MEETING AGENDA

Appearance Commission

Village of Homewood

August 01, 2024

Sheet Name: **EXTERIOR ELEVATIONS**
 Sheet Number: **A2.0**
 ©2024 Ridgeland Associates, Inc.

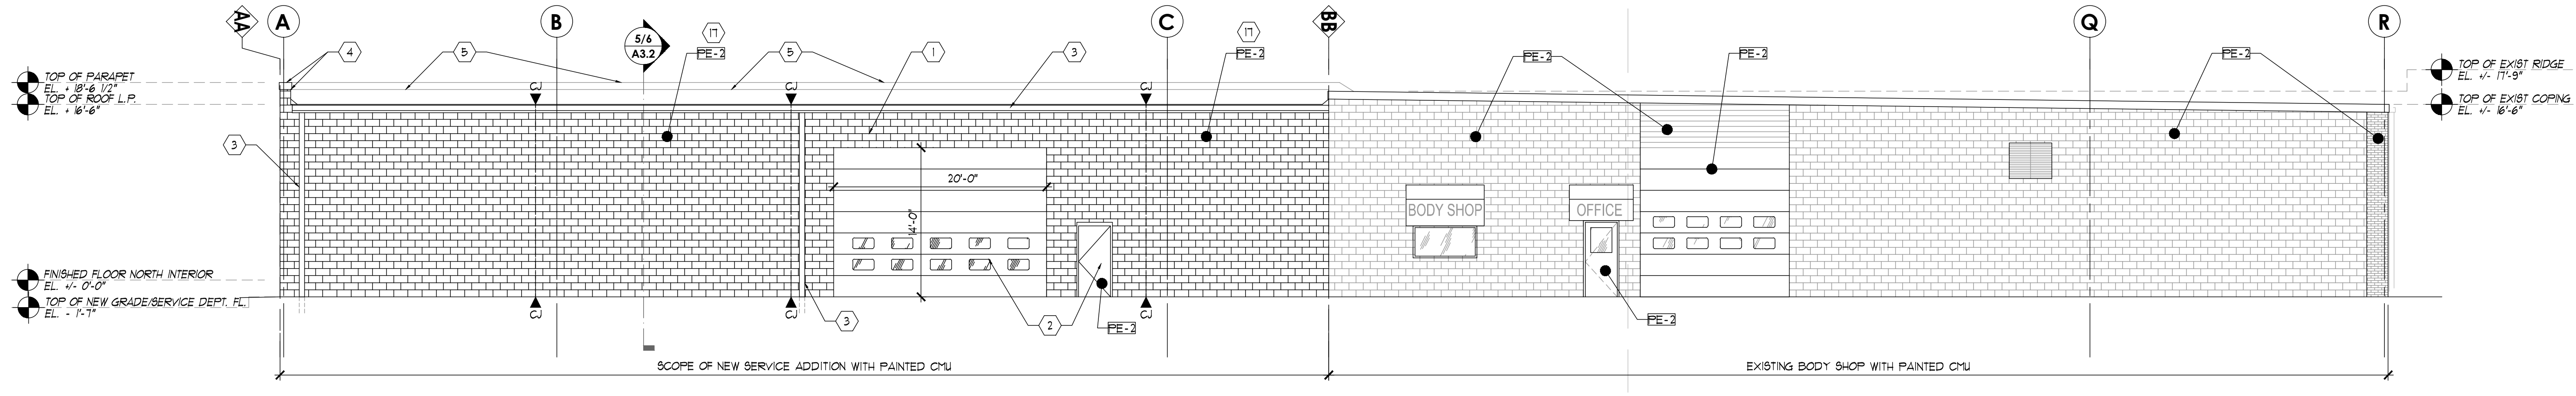
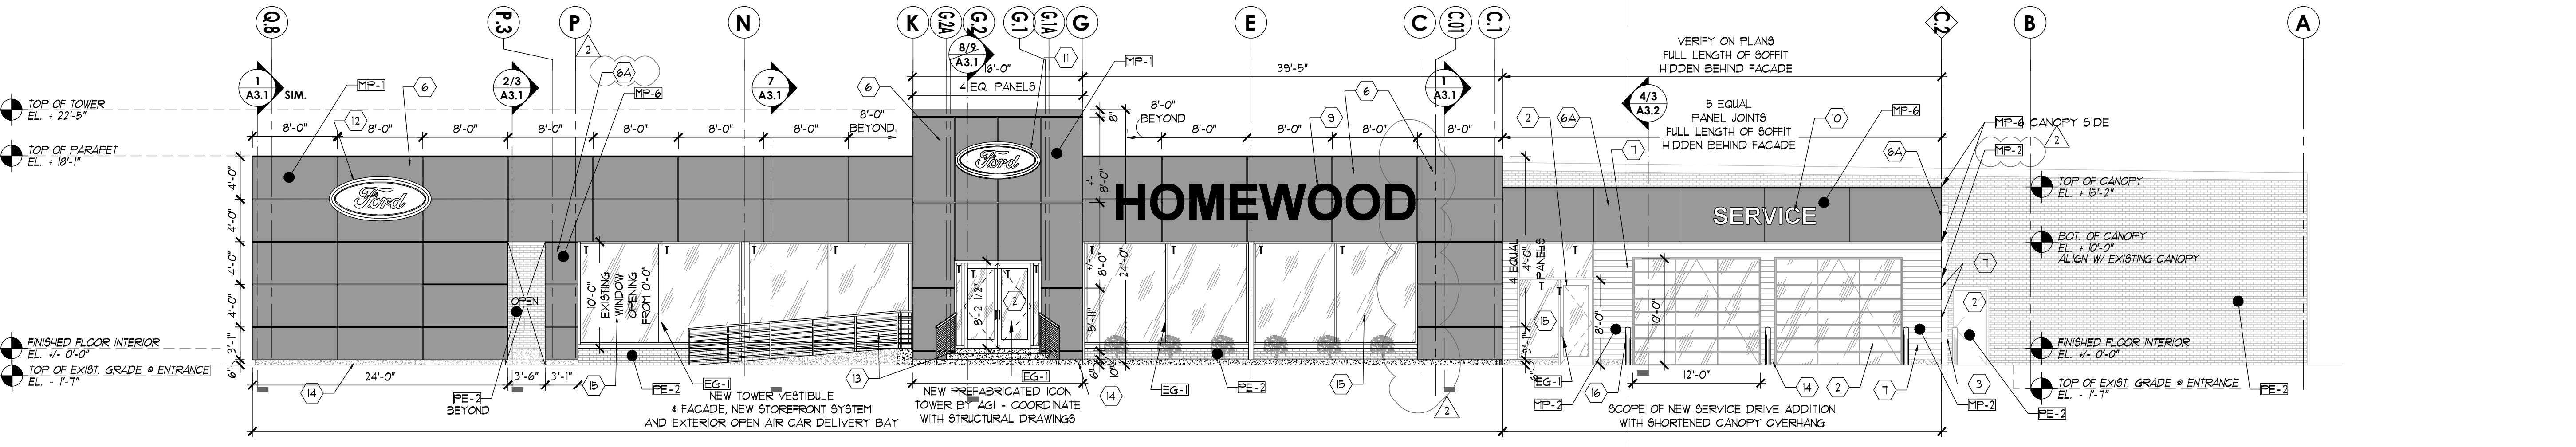
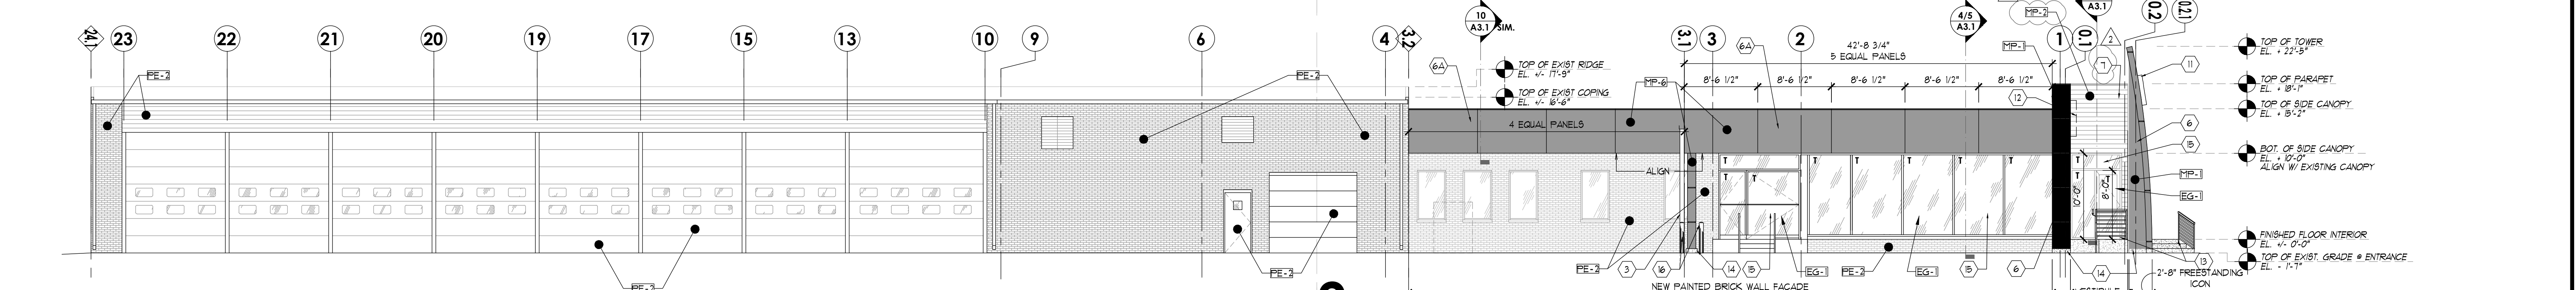
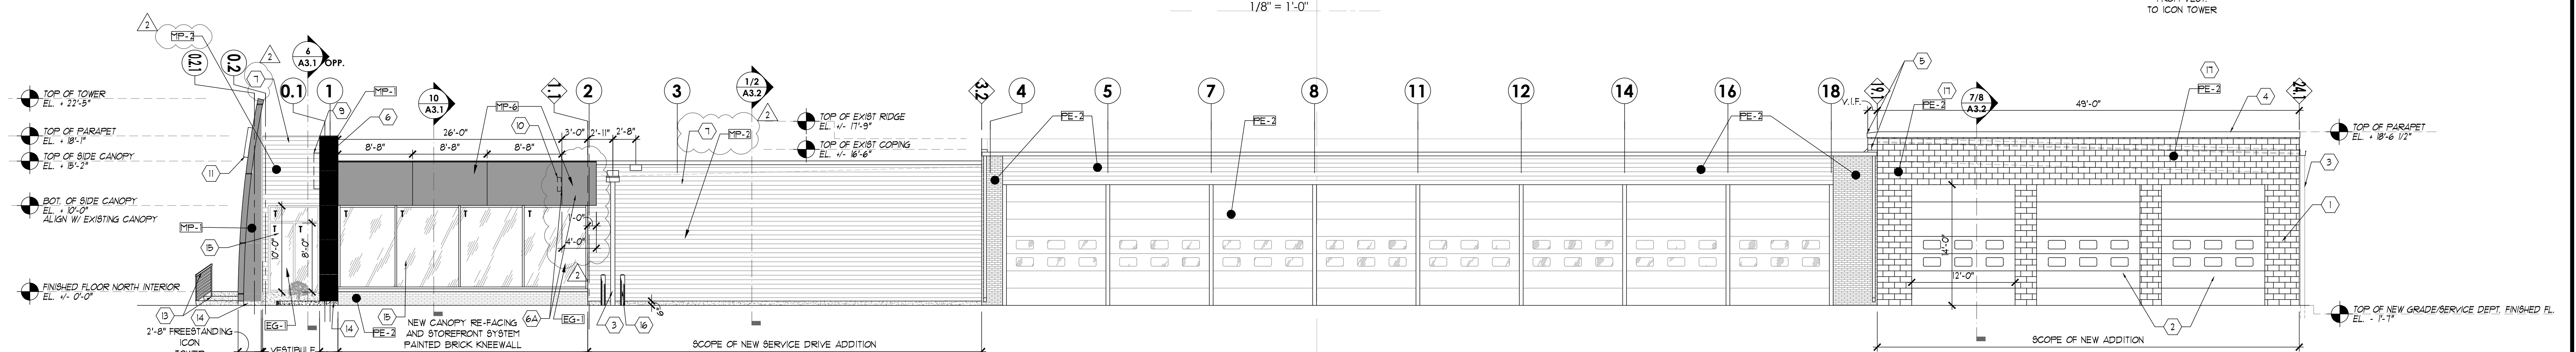
1. Replace corrugated metal paneling material (“SP-2”) on the proposed northern building expansion with a Tier I material, or a mixture of Tier I and Tier II materials, as identified in Section 44-05-11 of the Homewood Zoning Ordinance, or another approved material recommended by the Appearance Commission.
